RESPONSE TO WATER TREATMENT PLANTS: ON-SITE DISCHARGES EIA

- *Water Treatment Plants: On-site Discharges EIA*. Tonkin+Taylor 2021

On behalf of 1433 residents of Rarotonga¹, **Te Vai Ora Maori (TVOM) objects to the stream discharge of residuals from the Te Mato Vai water treatment system.**

CYCLIC WETLAND / TE MATO VAI REMEDIATION CONCEPT
Adapted from: *Section B-B Backwash/Scour Pond.*

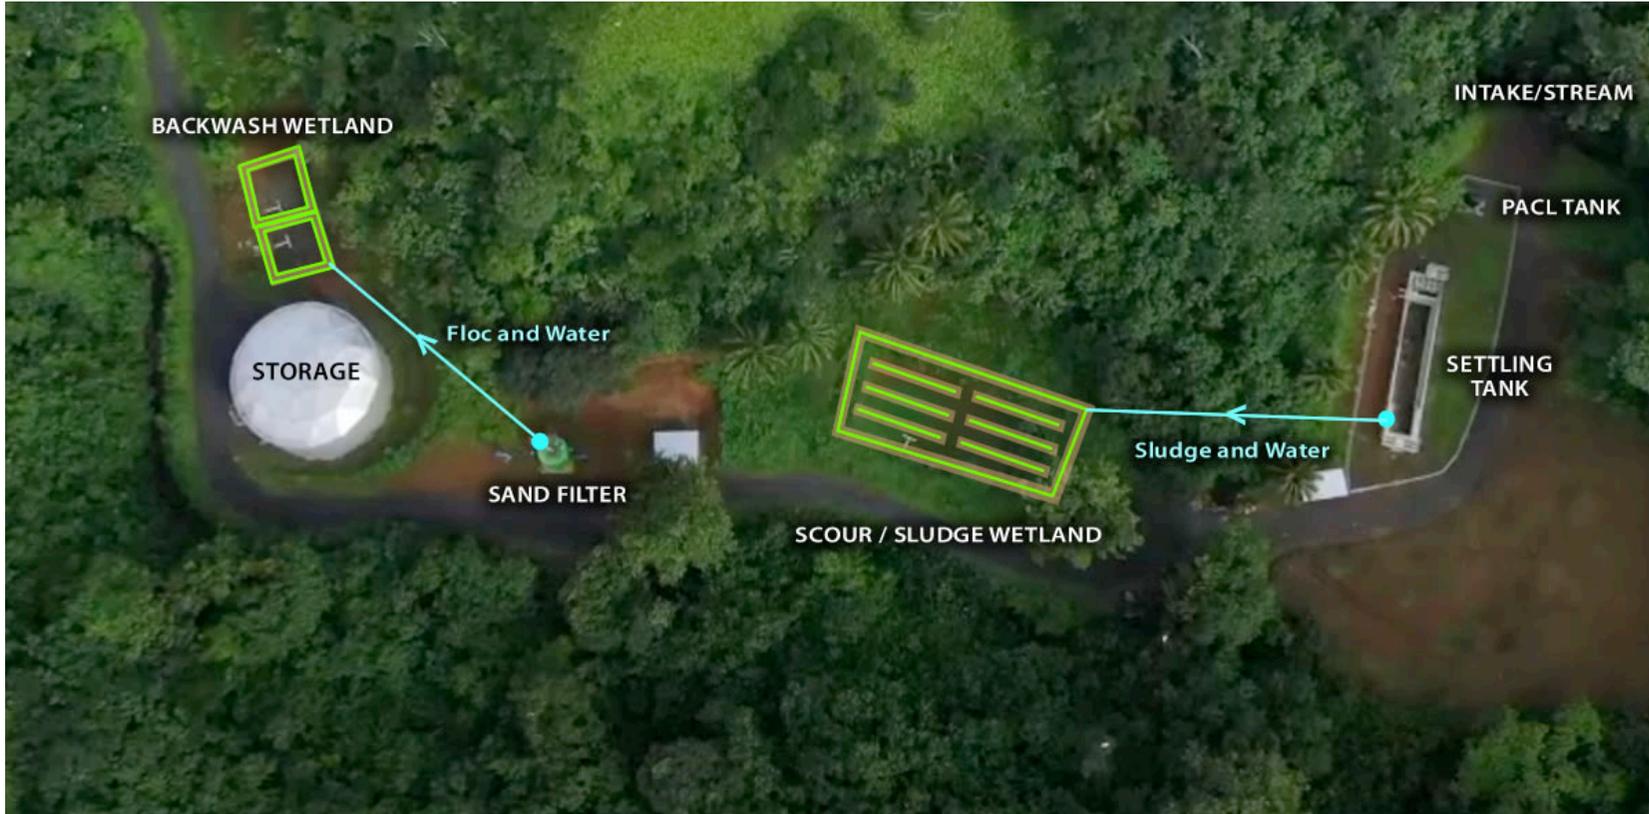
Scour (sludge) and Backwash ponds would be planted as cyclic vetiver wetlands. 'Cyclic' as the **ponds are flooded, and then allowed to dry-out**. This is good fit with operational process and maximises plant growth.

A supplementary enhancement is to plant vetiver downslope of the ponds (into the existing rip-rap. **When sludge is removed for permanent disposal**, the supernatant will be drained through the grass. The hedgerow would also minimise impacts of any unplanned overwash due to surface flooding.

In the remediated treatment process, wastewater will only be discharged to the Scour and Backwash Wetlands (formerly ponds). Constructing cyclic vetiver wetlands avoids the need for stream discharge.
